INFORMATION BULLETIN NO. 115

TO: ALL OWNERS OF J.H. FLETCHER & CO. NEW AND MODERNIZED MACHINES PURCHASED SINCE JULY 2009

SUBJECT: GROMMETS USED IN MCI LIGHT PACKING GLANDS

ATTACHMENT	133243	TITLE	DATE
3	MCI GROMMET REPLACEMENT KIT	01/28/10

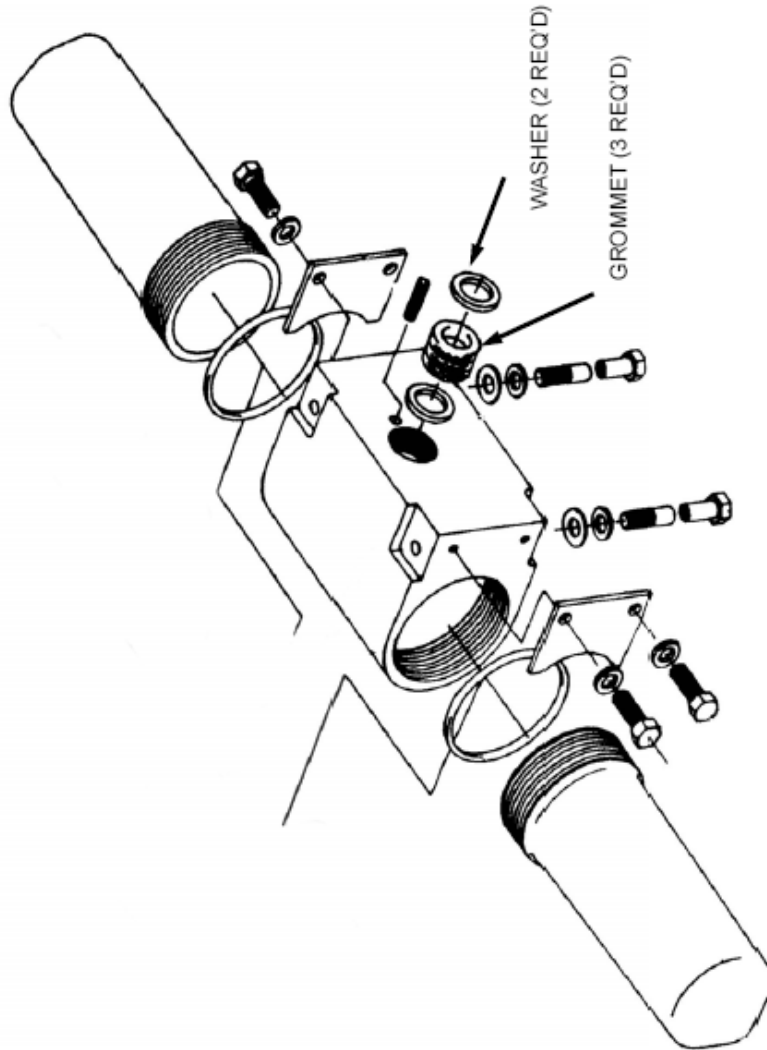
Enclosed is a breakdown sheet of the light fixture to indicate the location of the grommets on the lights (see Attachment 3).

This notice is to inform you of a problem with grommet packing gland assemblies Shipped after July 20, 2009 and before November 1, 2009. The problem is with the material thickness of each grommet. The approved thickness of the grommet is 0.250 +/- 0.020. MSHA is aware of this and we are working together to correct the problem.

EACH KIT CONTAINS:
60 GROMMETS
40 WASHERS
1 INSTRUCTION SHEET
1 PARTS SHEET

NOTE: EACH KIT CONTAINS ENOUGH MATERIAL TO REPACK 20 GLAND ASSEMBLIES.

1. Remove the locking device i.e. (lock screw or seal wire.)
2. With your hand, tighten the gland nut.
3. Check the gap between the housing and the side of the nut closest to the housing. If the gap is less than 1/8" replace the grommets and bushing.
(CONTACT MINING CONTROLS FOR REPLACEMENT GROMMET KITS)
4. If the gap is greater than 1/8", the gland assembly is good.
5. Replace the locking device.
